CORRESPONDENCE

VINA STAKEHOLDER ADVISORY COMMITTEE

Subject: Vina, Butte Basin setting process

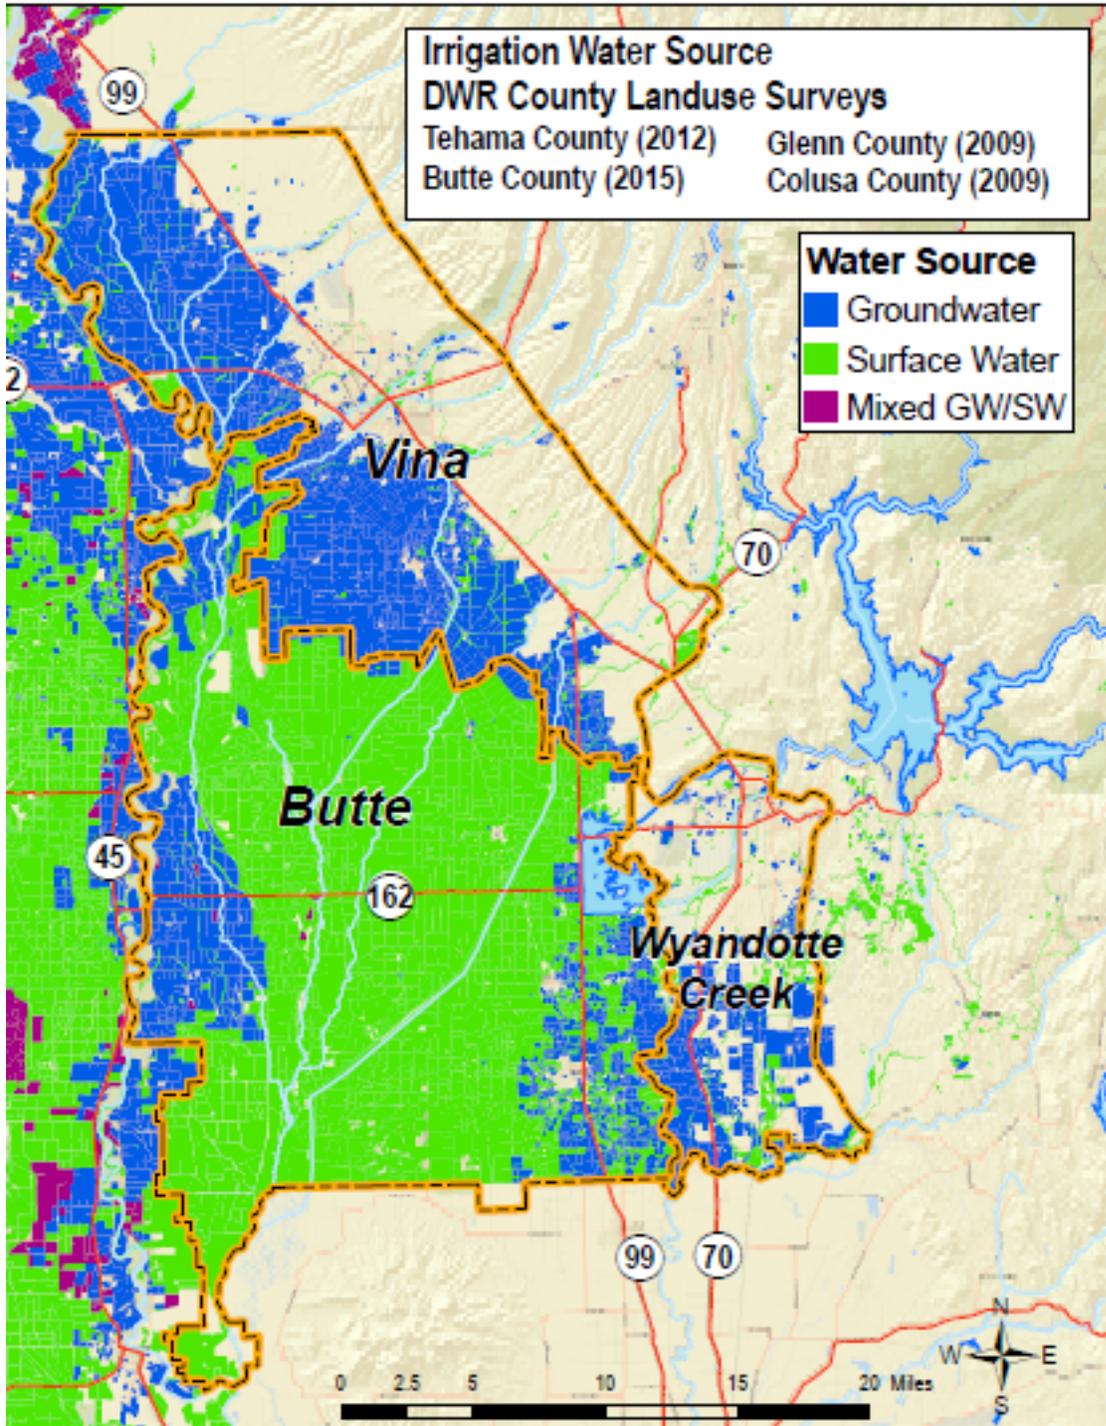
I actually recently came across documentation in a report that describes how geologic features in the southern part of the Butte subbasin (Willows fault, Colusa dome and Sutter Buttes) affect the direction of groundwater flow in that area:

These structures cause a deviation in the typical regional direction of groundwater flow which is toward the Sacramento River from the northeast to the southwest and from the northwest to the southeast. However, in the area of the Gray Lodge Wildlife Refuge north of the Sutter Buttes, groundwater flow takes an anomalous path and converges toward the Butte Sink. Groundwater from the central portion of the Butte subbasin flows southwestward, while groundwater from the Sacramento River flows southeastward and eastward. The converging groundwater flow in this area is structurally controlled due to the intrusion of the Sutter Buttes to the east and the buried Colusa Dome to the west (DWR 2005).

All this to say, I think we would mostly expect relatively little flow across the Butte-Colusa subbasin boundary since generally the flow of groundwater in that area would be in a southerly direction and largely perpendicular to the subbasin boundary line. However, locally groundwater flow directions can change and depending on where the boundary line is in relation to those local conditions, interbasin

flows result. The map below does show a groundwater dependent area of Glenn county within the Butte subbasin (area in blue near the boundary)...perhaps there is some boundary flow from west to east in that area?? Just a guess at this time. We would need to dig into the details a bit more from the BBGM results to see if that's the case. And even better would be to look at results from C2VSim-FG and SVSim.
